SUBJECT: ISSUANCE OF AMENDMENTS - McGUIRE NUCLEAR STATION, UNITS 1 AND 2
(TAC NOS. M88120 AND M88121)

The amendments reduce the required minimum measured reactor coolant system flow from 385,000 gallons per minute (gpm) to 382,000 gpm.

SAFETY EVALUATION BY THE OFFICE OF NUCLEAR REACTOR REGULATION
RELATED TO AMENDMENT NO. 141 TO FACILITY OPERATING LICENSE NPF-9
AND AMENDMENT NO. 123 TO FACILITY OPERATING LICENSE NPF-17

MCGUIRE NUCLEAR STATION, UNITS 1 AND 2

Figure 2.1-1
 REACTOR CORE SAFETY LIMITS - FOUR LOOPS IN OPERATION

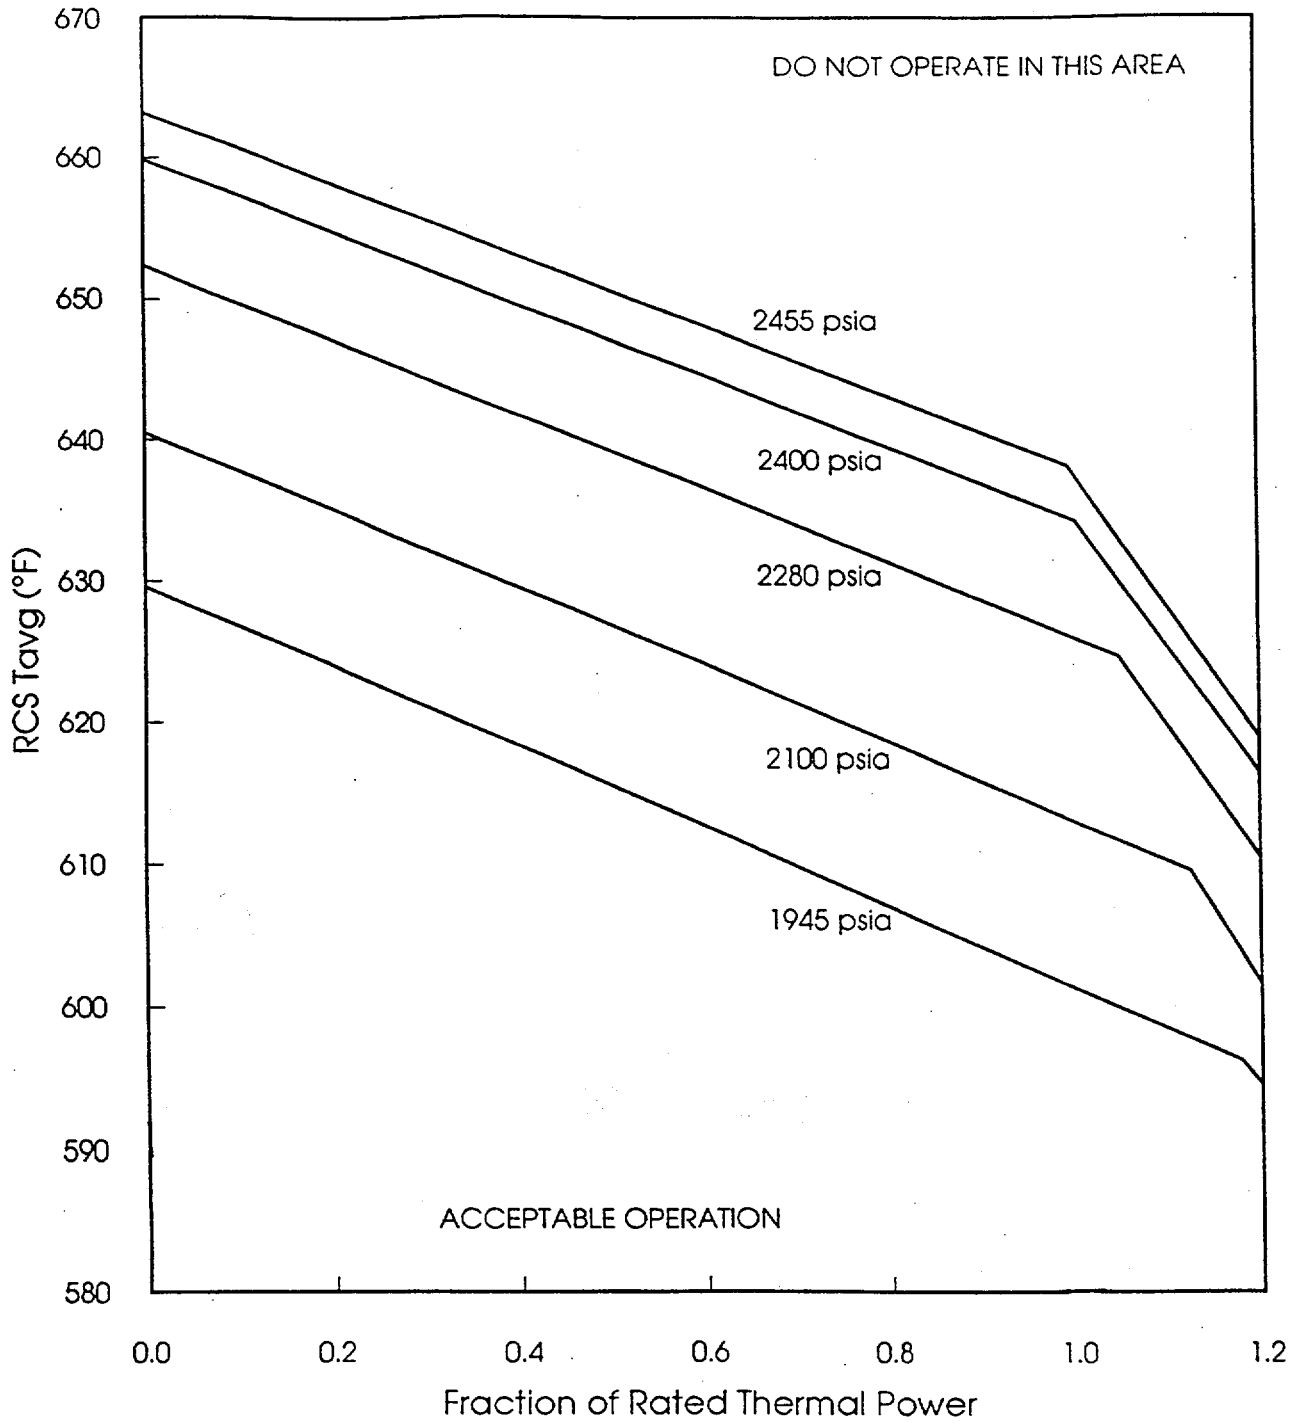
- 1) Figure 2.1-1, Reactor Core Protection Limits - Four Loops in Operation,

To support the reduction in measured minimum RCS flow (MMF), changes were required for the OP Δ T setpoints for McGuire, Units 1 and 2. These changes involved recalculation of the TS allowable values of the trip functions. The revised core thermal limits were generated to reflect the reduced MMF of 382,000 gpm. Based on these new protection limits, the OT Δ T setpoint constants (Note 1 of Table 2.2-1), and the OP Δ T setpoint equation constants (Notes 2 and 3 of Table 2.2-1) were revised to reflect the necessary changes. The impact of the reduced flow on the coefficients was partially offset by a reduction in the margin assumed in the calculation of the coefficients.

Figure 3.2-1 Reactor Coolant System Total Flow Rate Versus Rated Thermal Power - Four Loops in Operation

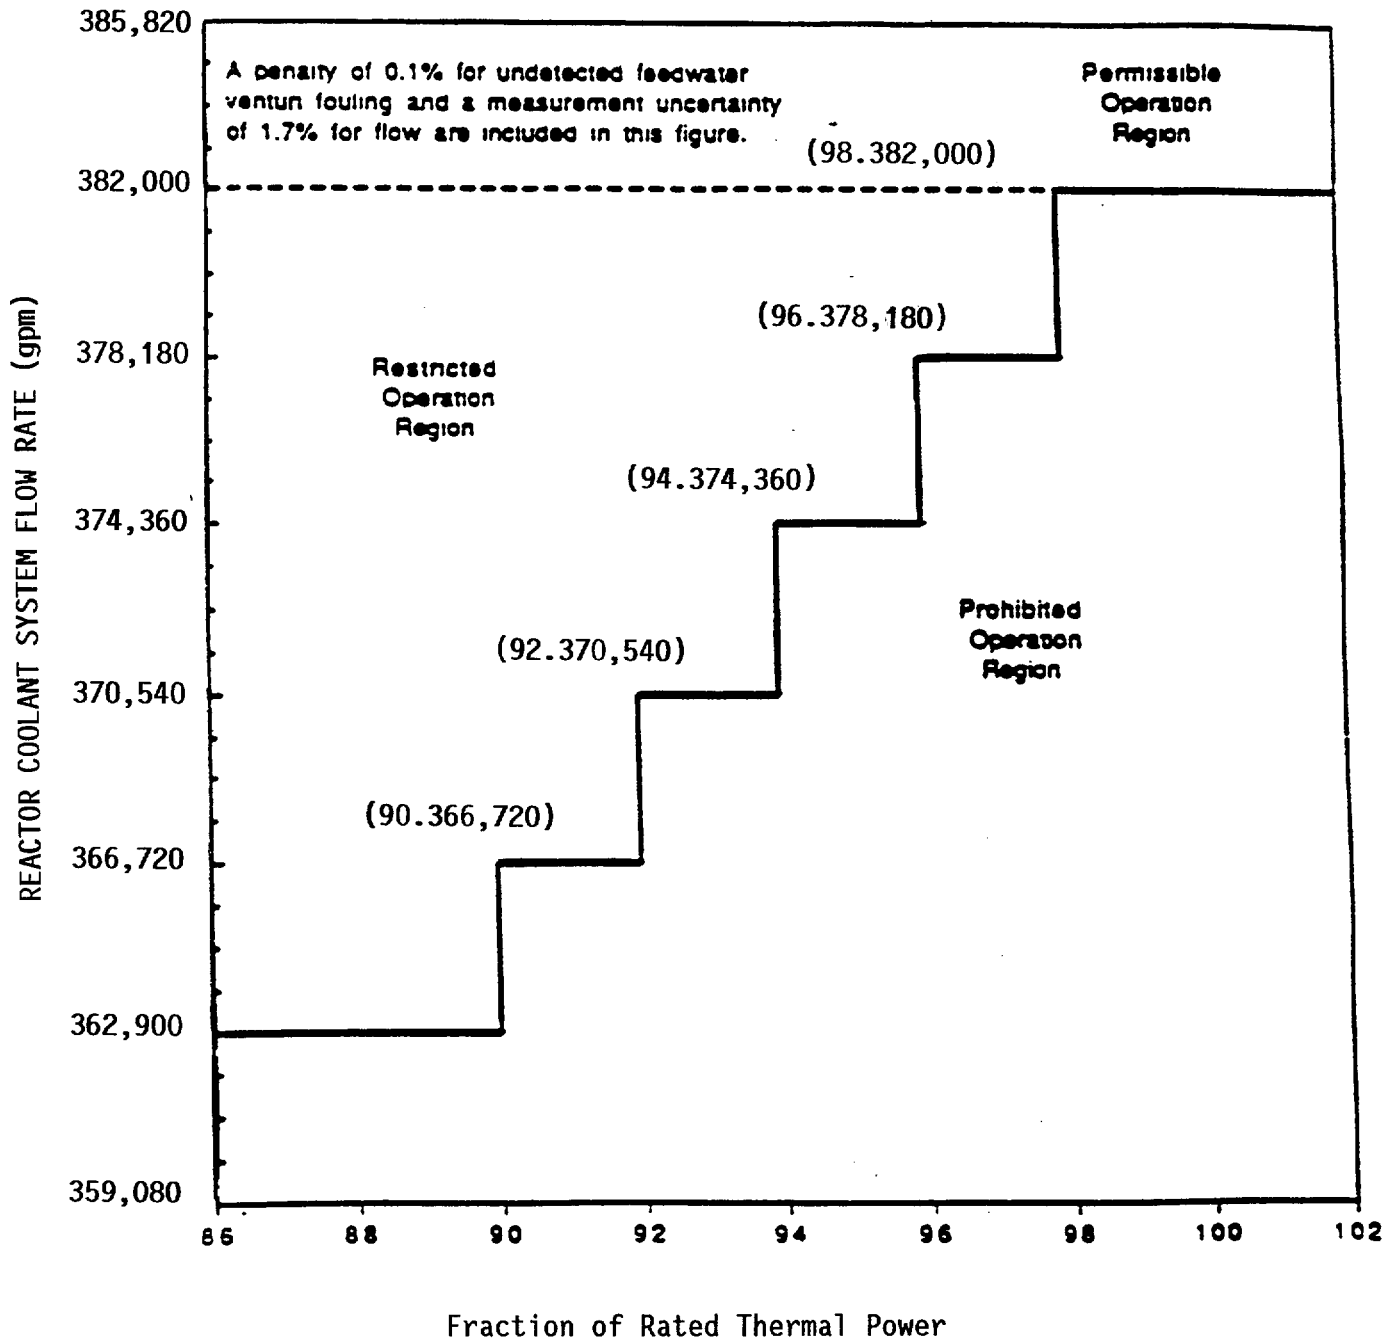
- 2) Figure 3.2-1, Reactor Coolant System Total Flow Rate Versus Rated Thermal Power - Four Loops in Operation, and
- 3) The overtemperature delta T (OT Δ T) and overpower delta T (OP Δ T) setpoint equation constants in Table 2.2-1, Reactor Trip System Instrumentation Trip Setpoints.

The thermal hydraulic design for the McGuire units was analyzed by the licensee with the reduction in RCS MMF to 382,000 gpm. The reduced flow rate resulted in a slight reduction of the margin in the core DNB limits. TS Figure 3.2-1, Reactor Coolant System Total Flow Rate Versus Rated Thermal Power - Four Loops in Operation, was revised to reflect the lower allowable

flow rate. For the changes made in RCS flow at reduced power, the licensee stated (Reference 2) that the RCS flow values were determined using the same 2% power per 1% flow reduction factor used in the existing TS figure. The axial Flux Difference Limits, TS Section 3.2.1, are unchanged and all the current thermal hydraulic design criteria are satisfied at the reduced flow conditions.
